## **Amendment No.1**

**Subject: Amendment to the Tender Enquiry Document**

**Ref:Tender Enquiry No.: HLL/PCD/BBC/01/13-14 dated 21/01/2014.**

**BUILDING CONSTRUCTION FOR 1.5 T MRI CENTER ATVSS MEDICAL COLLEGE, BURLA & MKCG MEDICAL COLLEGE, BERHAMPUR. (TURNKEY)**

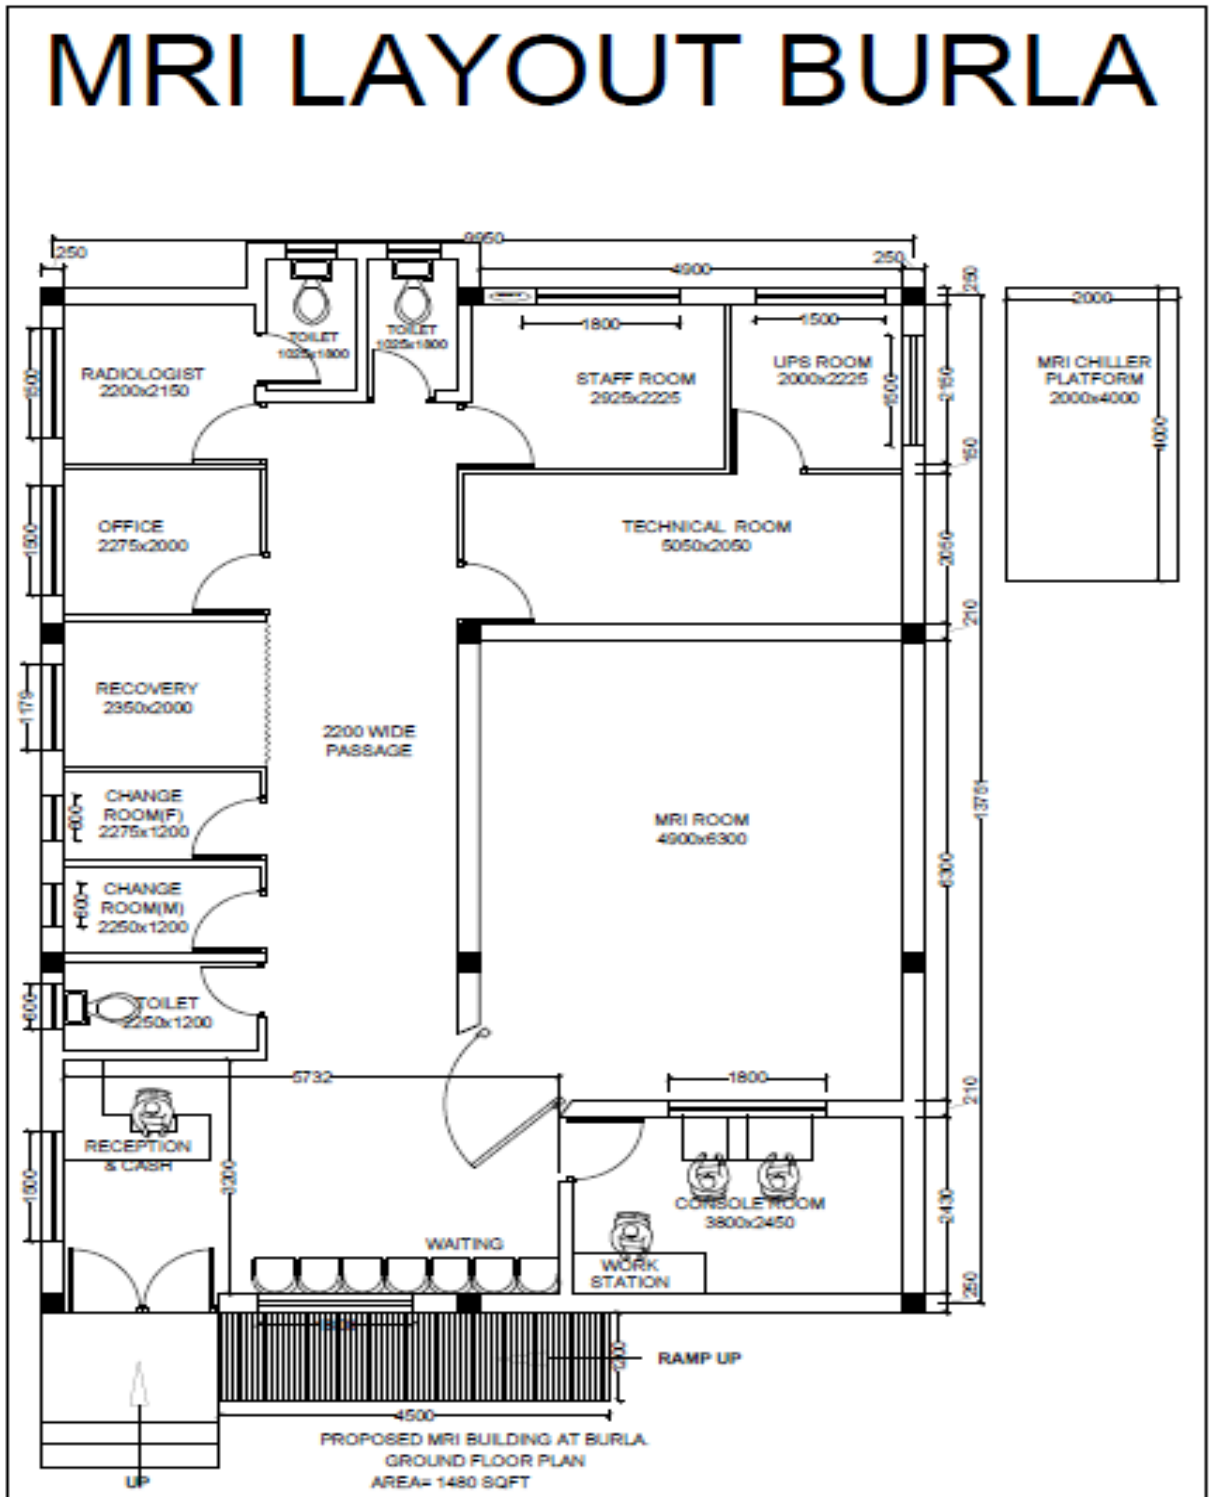
2. The concept plans of both sites are given below for reference. The actual site plan drawing and the list of works along with complete specification (B.O.Q) for civil, public health, electrical; air conditioning must be spelt out and provided along with the tender. While preparing the plan, the following aspects have to be addressed.

- i. Construct the Building with suitable structural strength of foundation and superstructure.
  - ii. Care should be taken to provide easy negotiation of the patient stretchers/ trolleys through corridors and doors.

- iii. RF shielding for doors, walls, glass viewer, etc.
  - iv. Furniture : Workstation, Chairs, shelves & Cabinets etc.
  - v. Patient recovery bed with accessories/side table etc.

- vi. Patient stretcher and other furniture / accessories to make the scan center functional.
  - vii. The chiller platform and DG platform to be so located that it does not hinder the smooth functioning of the scan center or neighbouring facilities.

## MRI SCAN CENTER LAYOUT - BEHRAMPUR

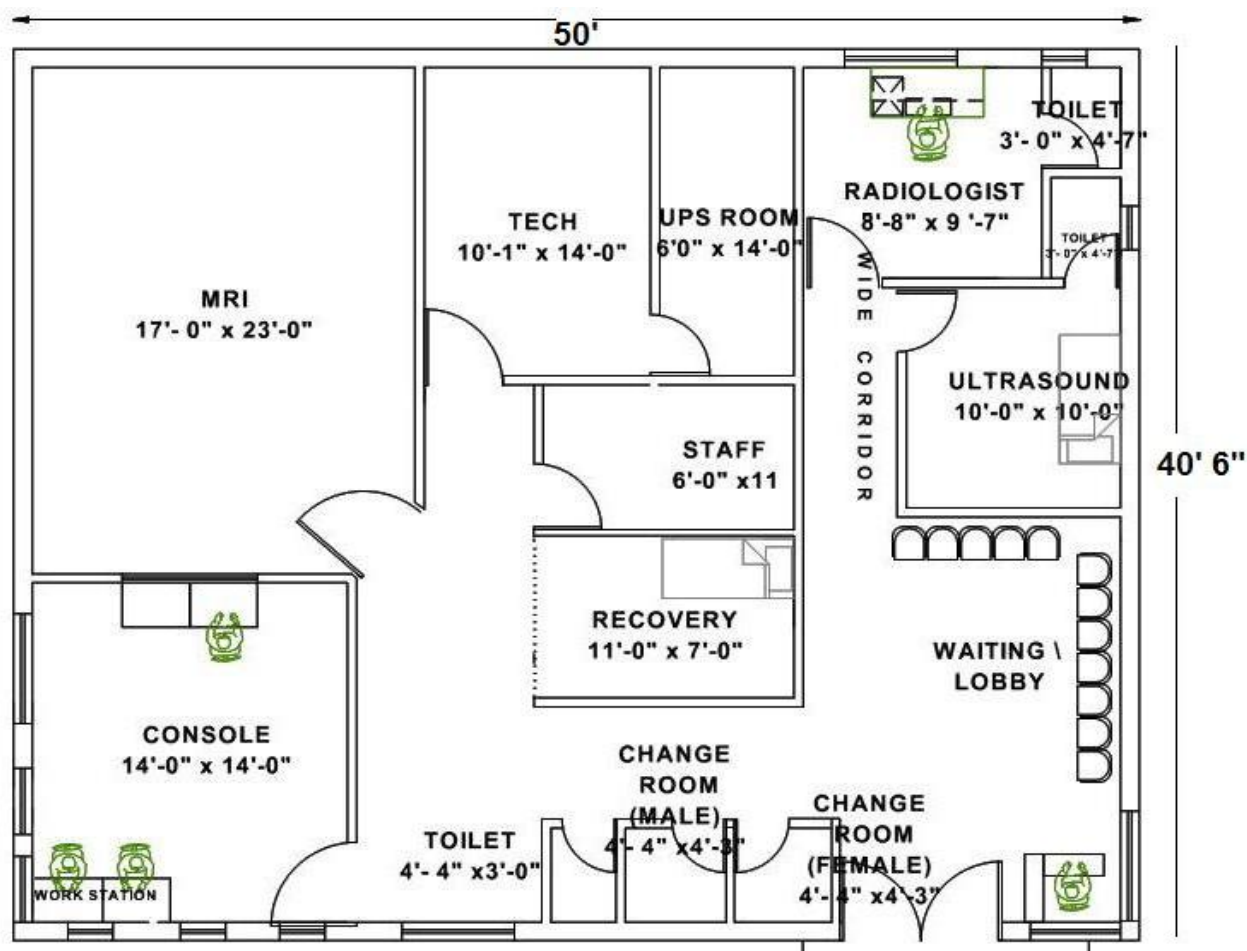
**5.1** -The concept plans of both sites are enclosed for only for reference. The supplier should inspect the proposed land and submit all the detailed structural and architectural drawings and BOQ for the proposed MRI Scan Centres along with tender.

**5.2.** Construction of suitable building(s) at proposed site(s) as per the final approved plan(s) shall include the following rooms:

1. MRI Room
2. Console room
3. Technical room
4. UPS room
5. Ultrasound room
6. Reception area & Cash counter
7. Patient waiting area
8. Radiologist room

9. Staff room
10. Recovery Room
11. Change Rooms (M & F)
12. Toilets
13. MRI Chiller platform

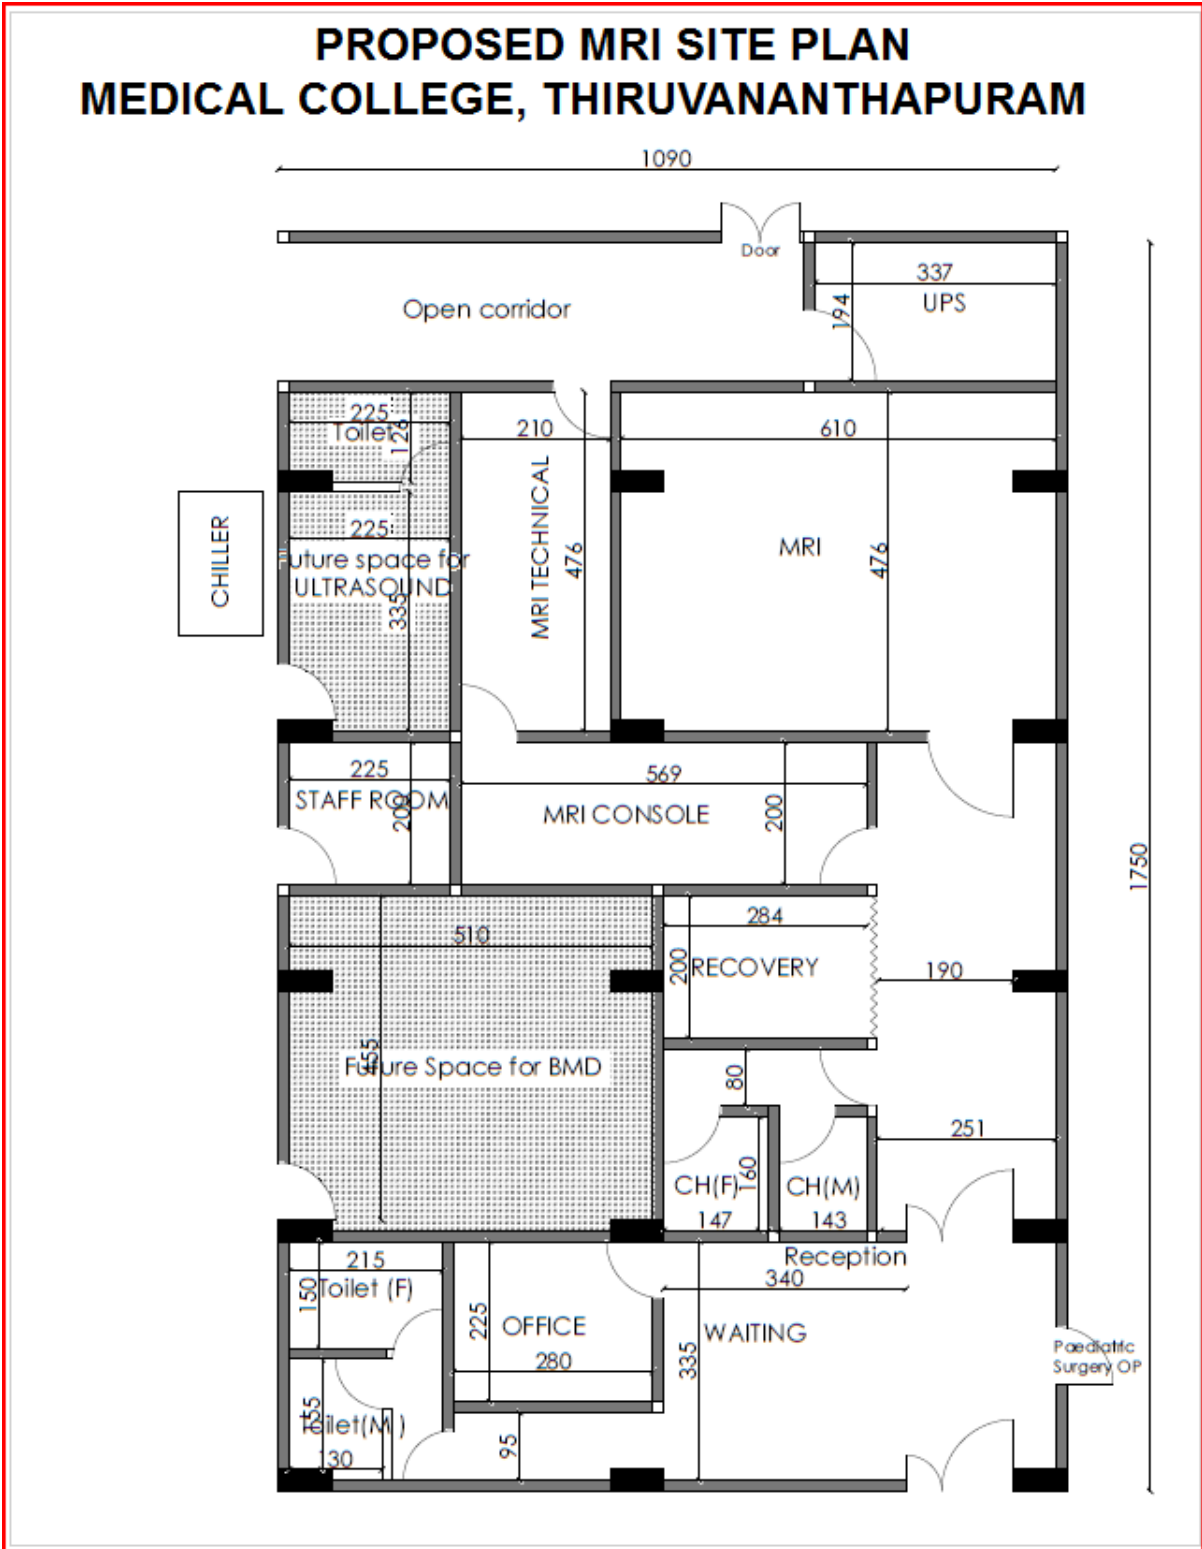
*The cost of site modification for the area shown in the schematic plan for Medical College, Kozhikode & Medical College, Thiruvananthapuram (given below) and the cost of Air-conditioning of Tonnage 10 TR will be considered for Ranking / Evaluation purpose.*

## PROPOSED MRI SITE PLAN , KOZHIKODE

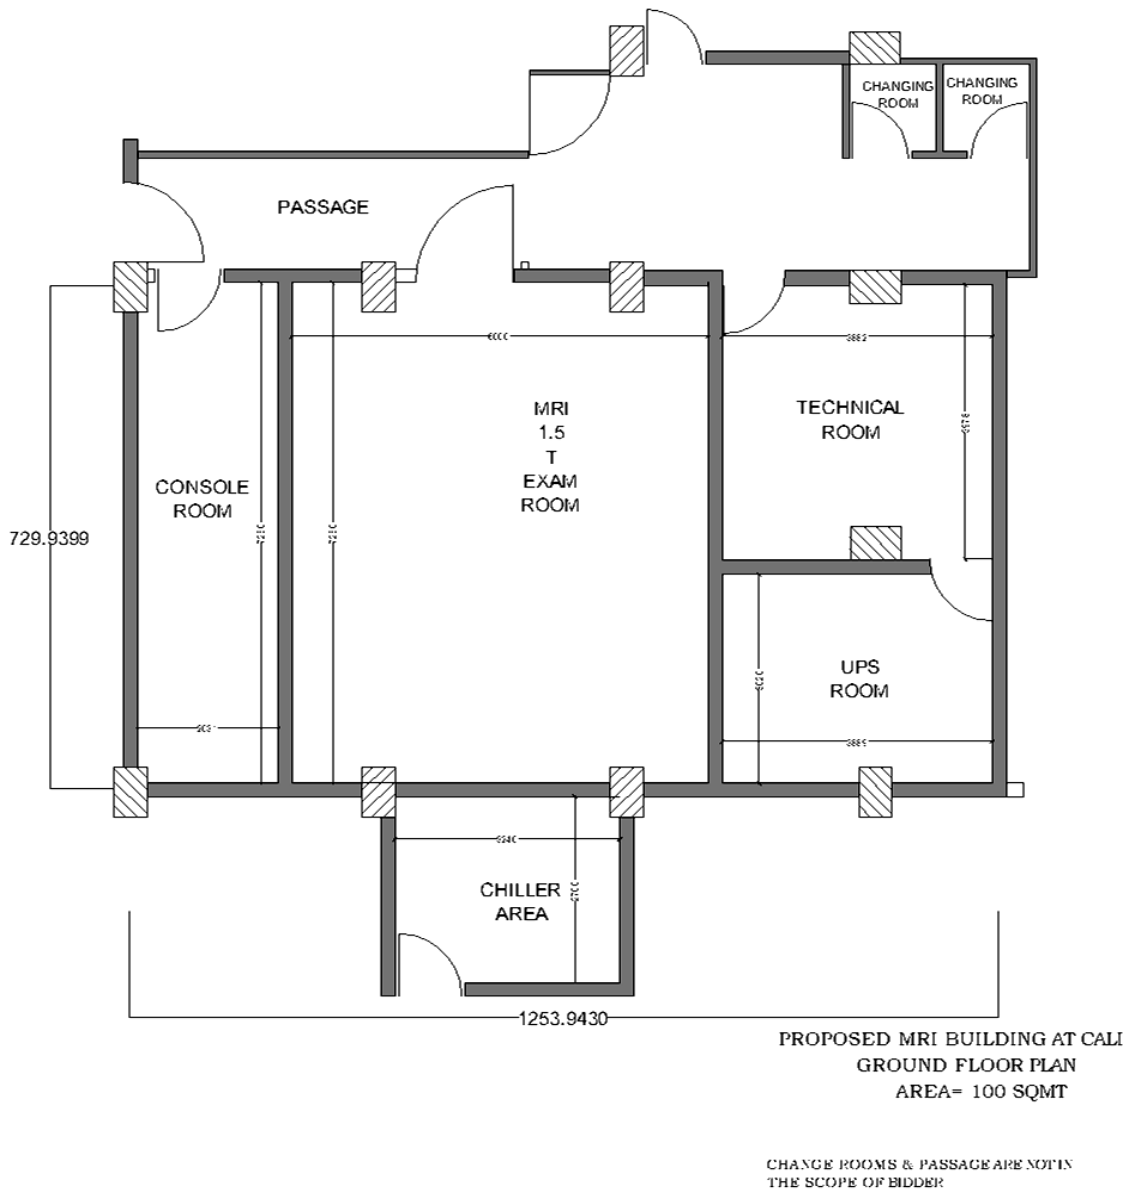
The turnkey area shown in the schematic plan given below.:

*The actual area of turnkey works done will be considered for payment, based on the site measurements.*
